**RESPONSE TO NRC QUESTIONS ON FORT CALHOUN'S
REFINED SEISMIC SPECTRA**

U.S. Nuclear Regulatory Commission

Omaha Public Power District

October 1990

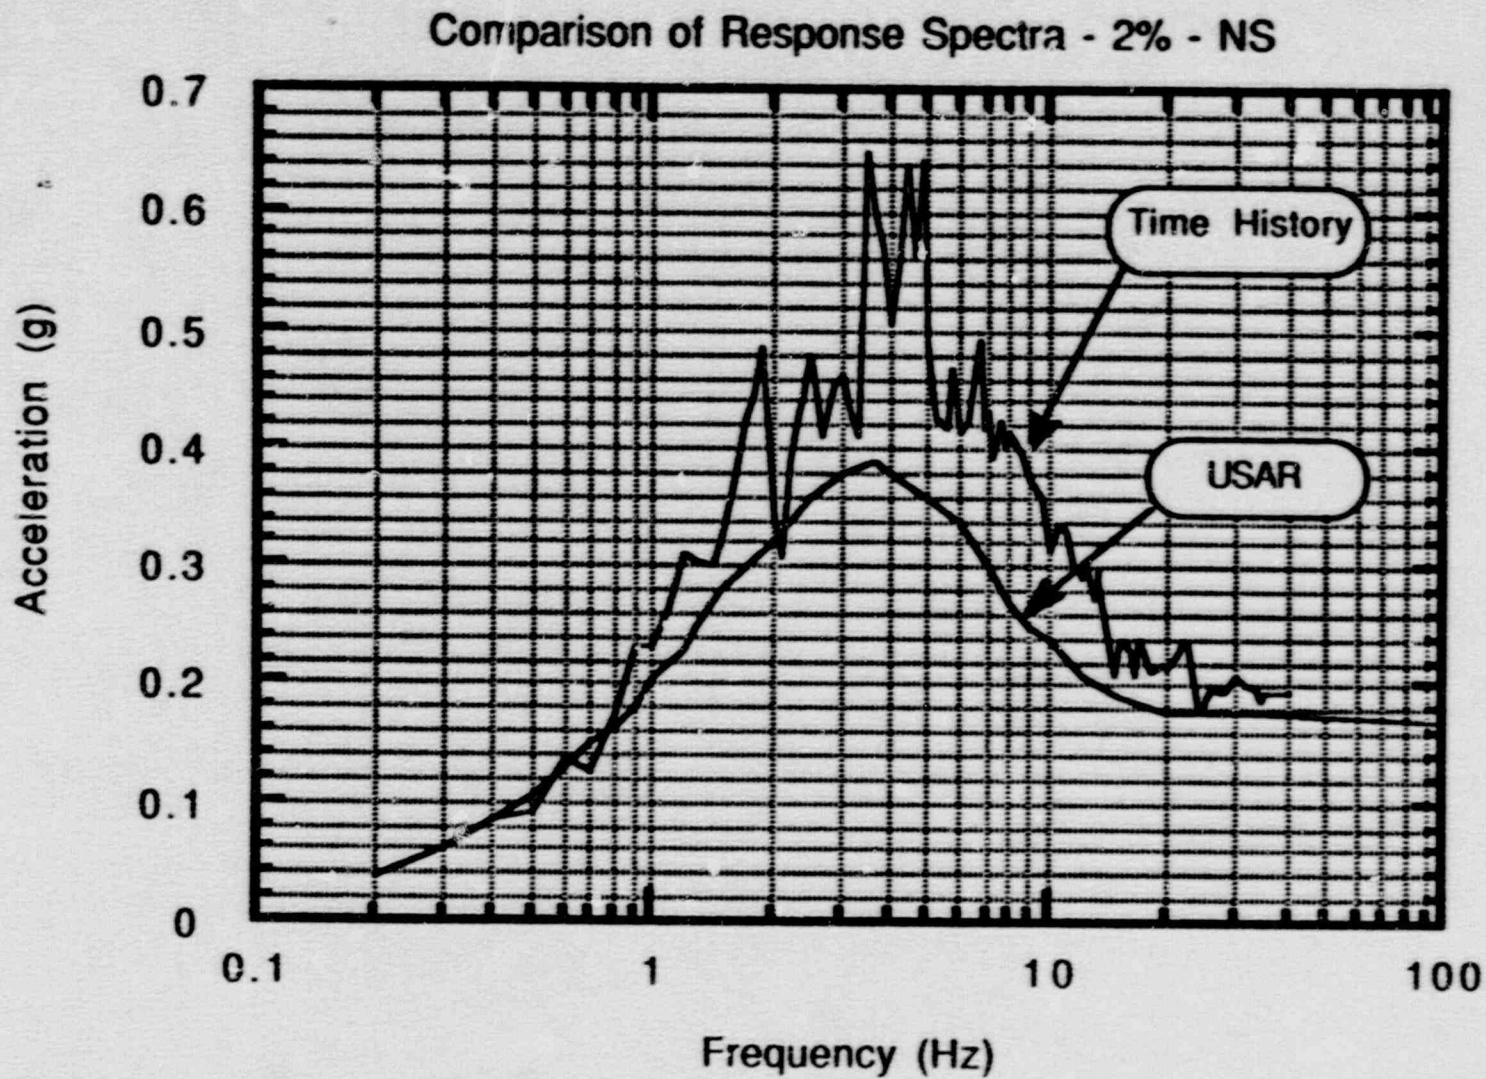
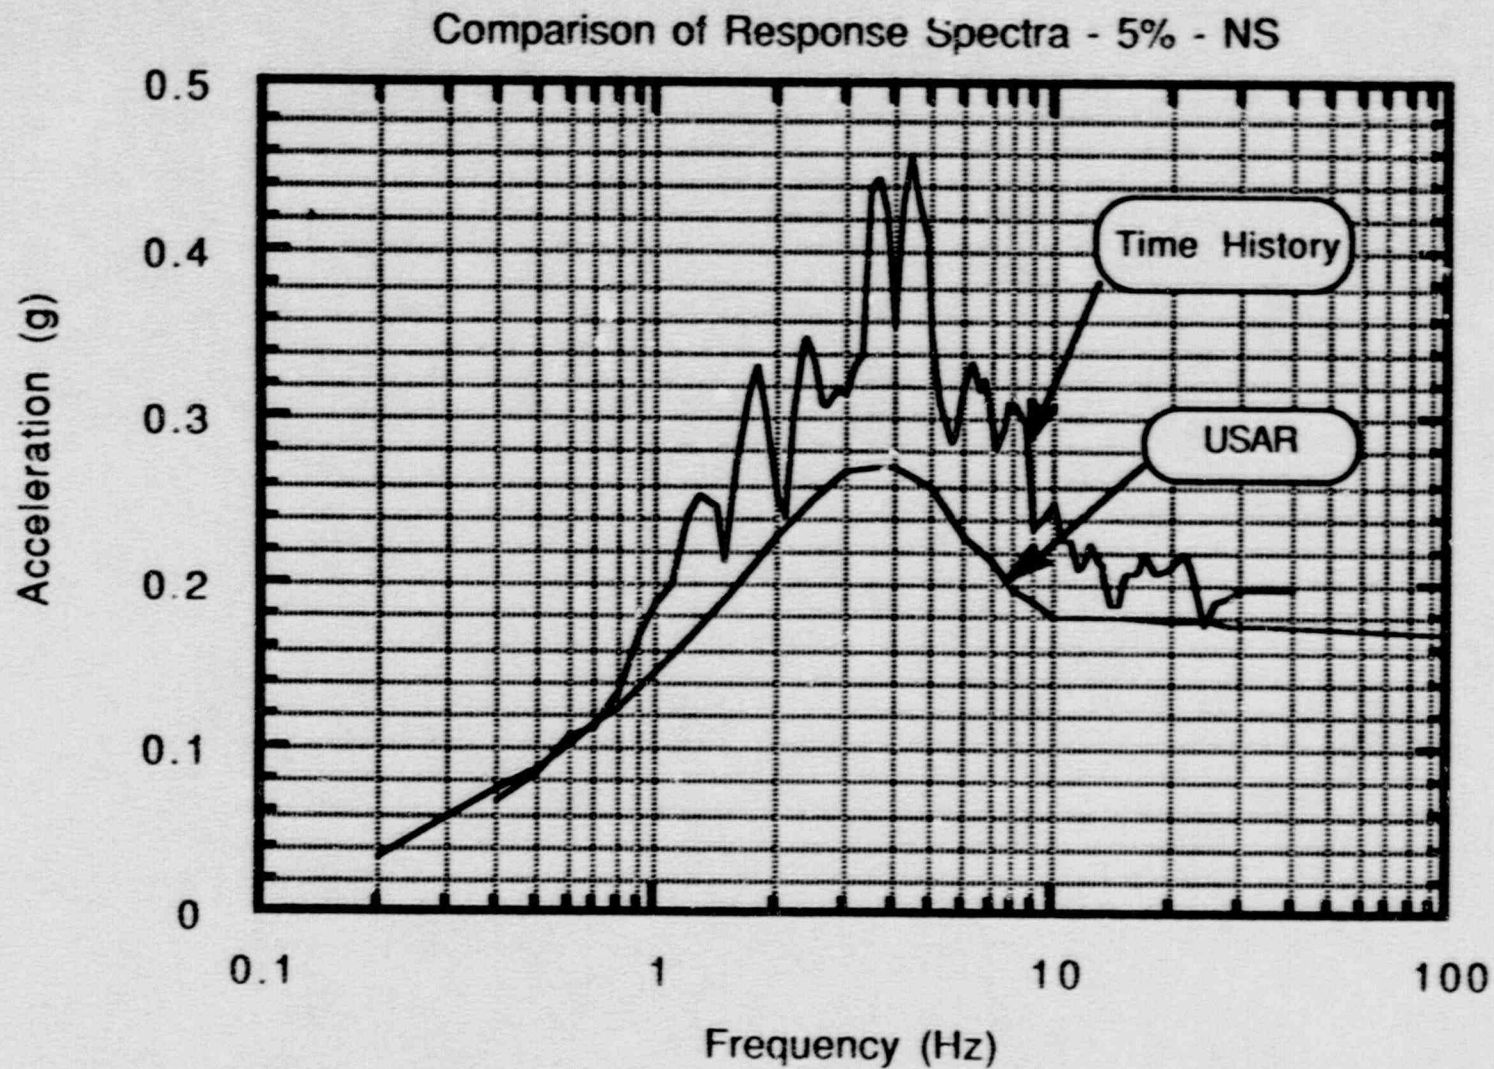
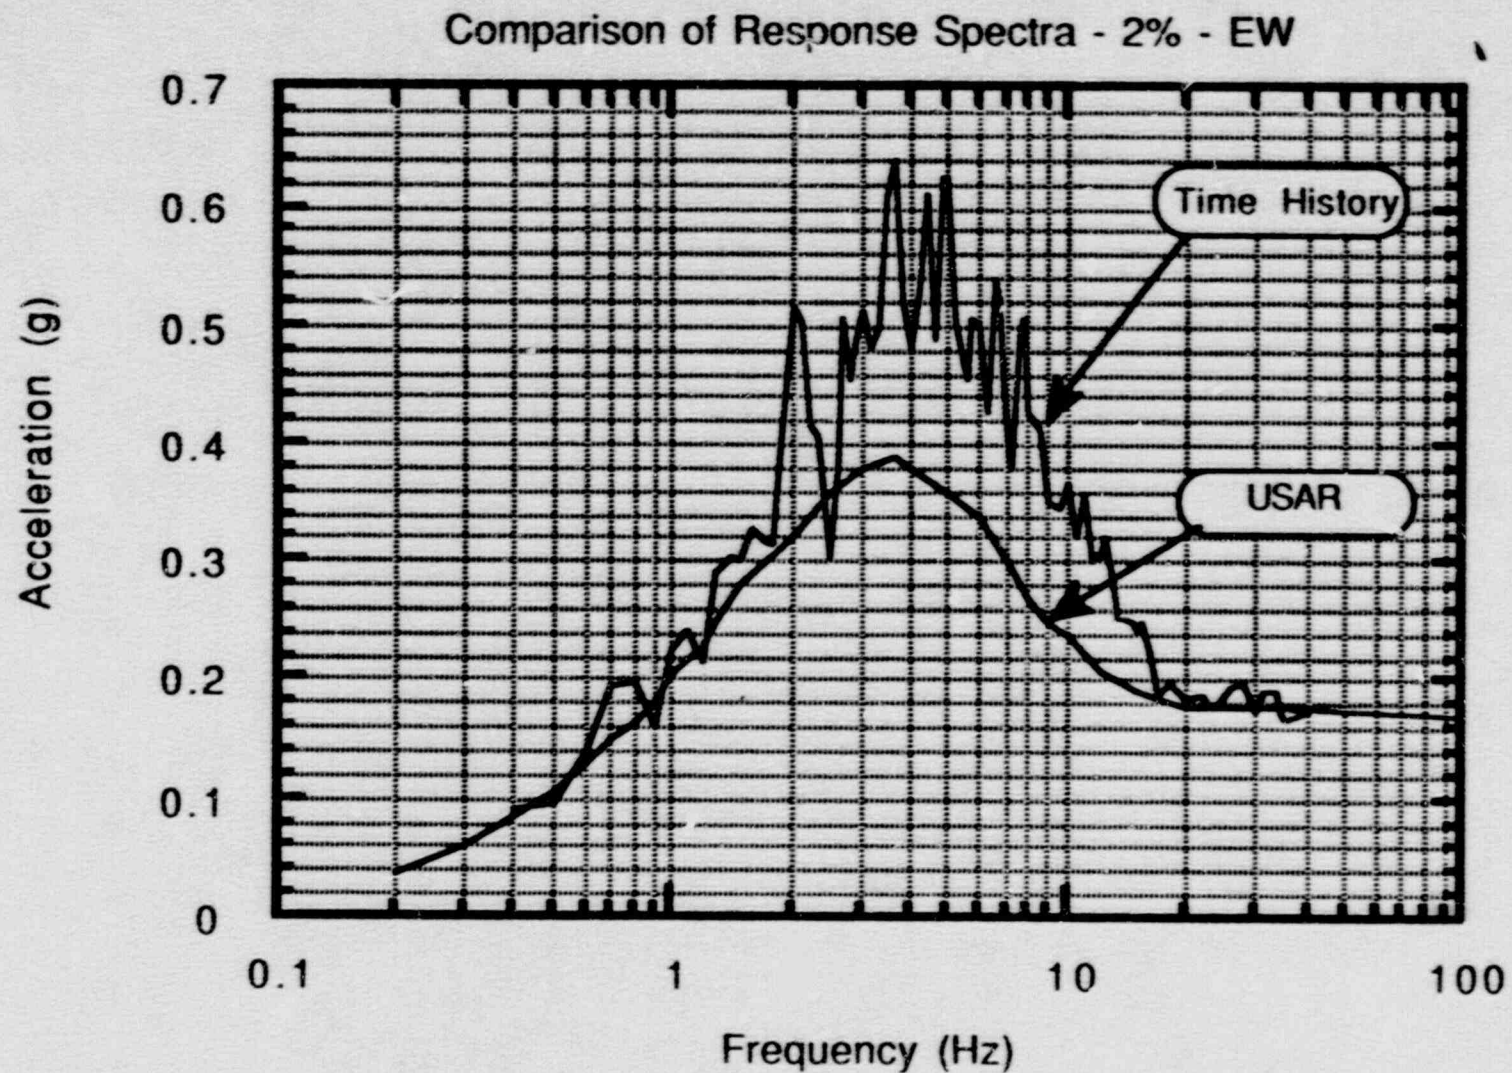
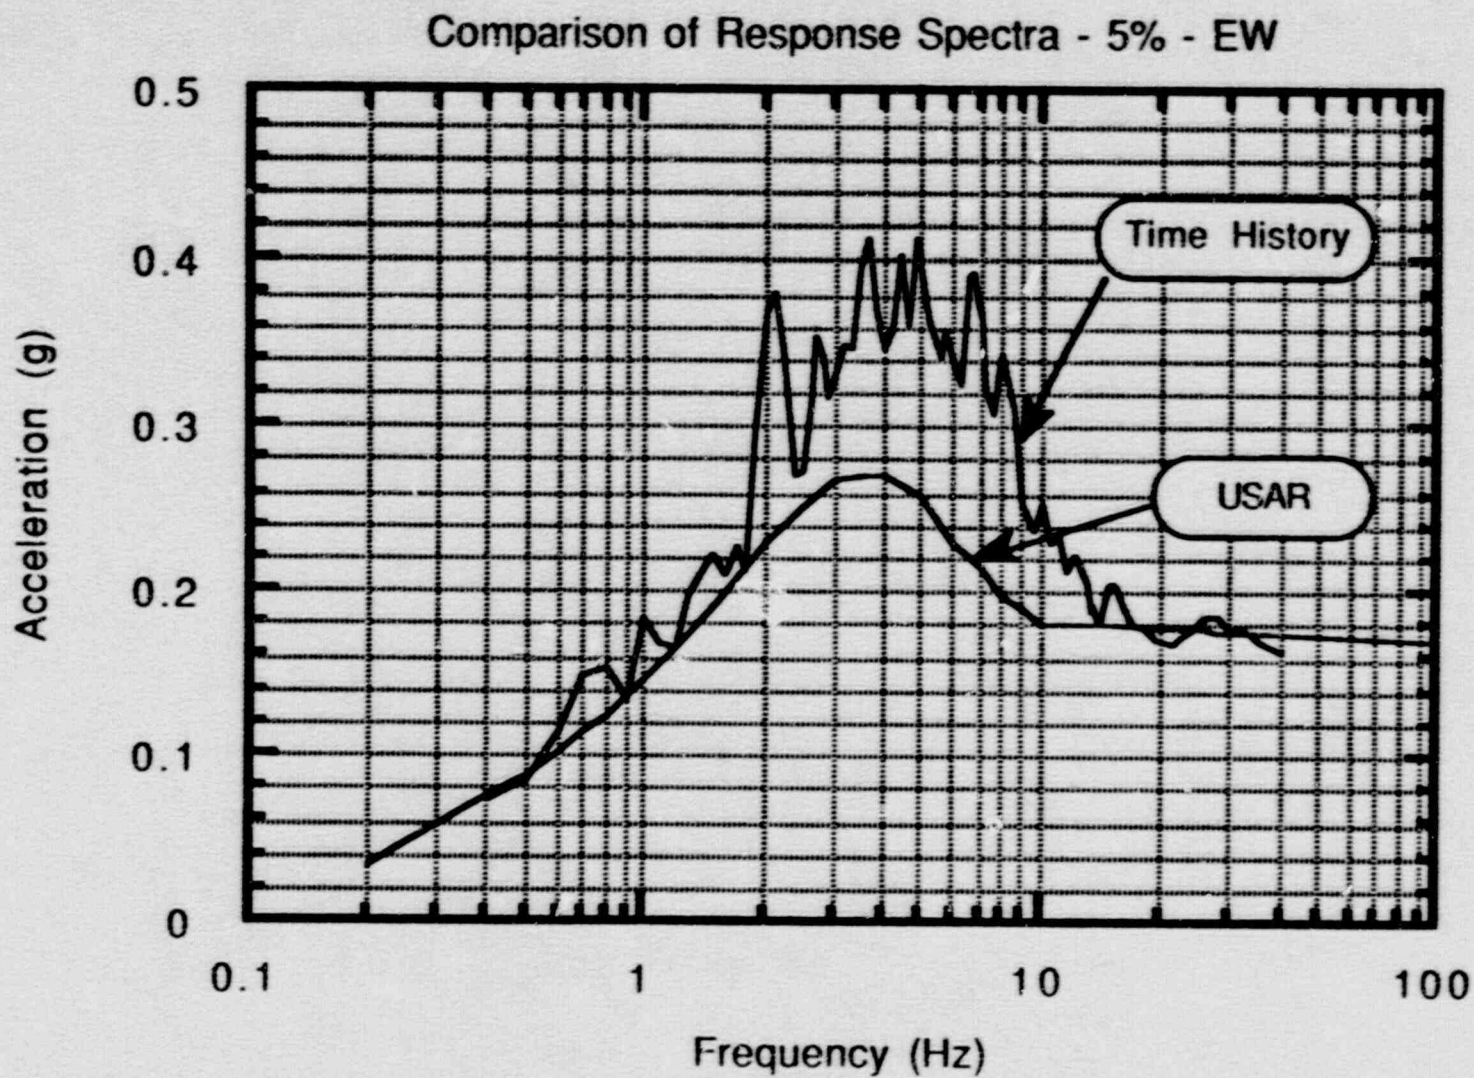
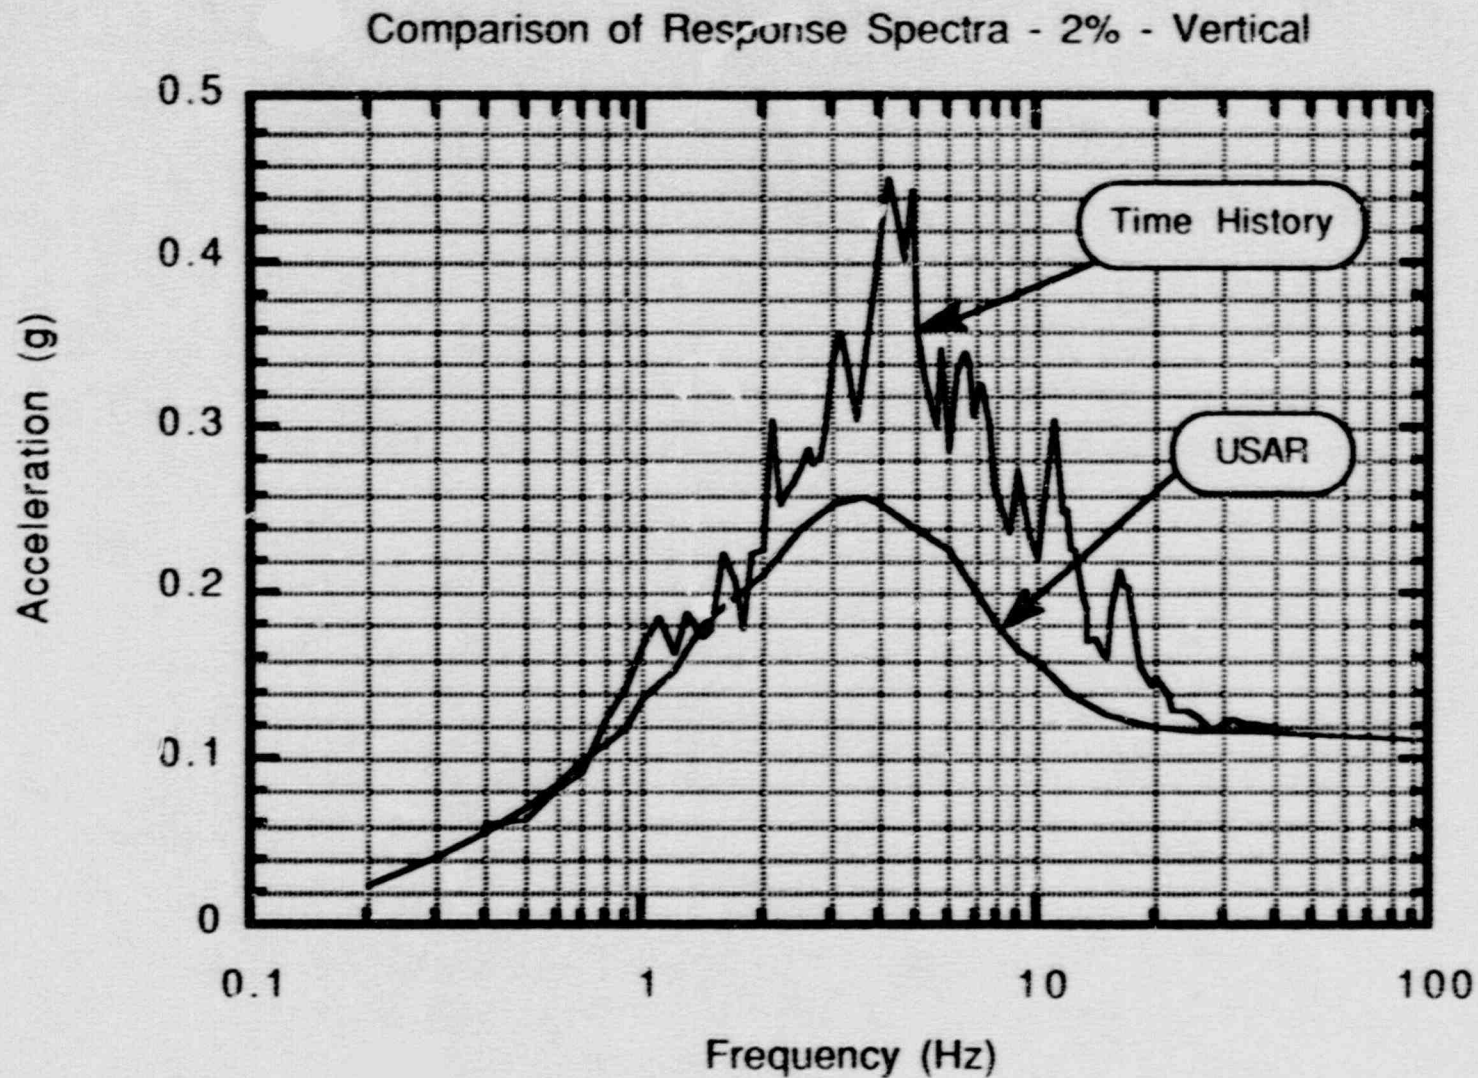
- (1) OI: (a) The Standard Review Plan (SRP) (NUREG-0800) recommends that the Power Spectral Density function (PSD) of an artificial time history used for single time history analysis meet a target PSD spectrum (NUREG/CR-3509).
- (b) The floor response spectra were calculated for a number of damping values ranging from 1 percent to 10 percent. To meet SRP requirements a check must be made that the response spectra of the artificial time history envelope the design response spectra for all damping values used in the response analysis.
- (c) The SRP recommends that the stationary phase strong motion duration of the artificial time history should be between 6 and 15 seconds.
- (2) RAI (a) Provide the information that the intent of the SRP recommendations are met.
- (b) Provide Impell's version of SIMQKE together with its user's manual.

- (b) Checks were made in Impell Calculation THG-1 to verify that the response spectra obtained from the three artificial time histories (NS, EW and vertical directions) envelop the USAR ground spectra. The spectra checks were performed for 2% and 5% damping, since the USAR design ground spectra are available only for 0, 0.5, 2 and 5% damping. The results from the checks are also included, in Figures 1.7 to 1.12, which show that ample margin above the design ground spectra exists for all directional time histories and damping values.
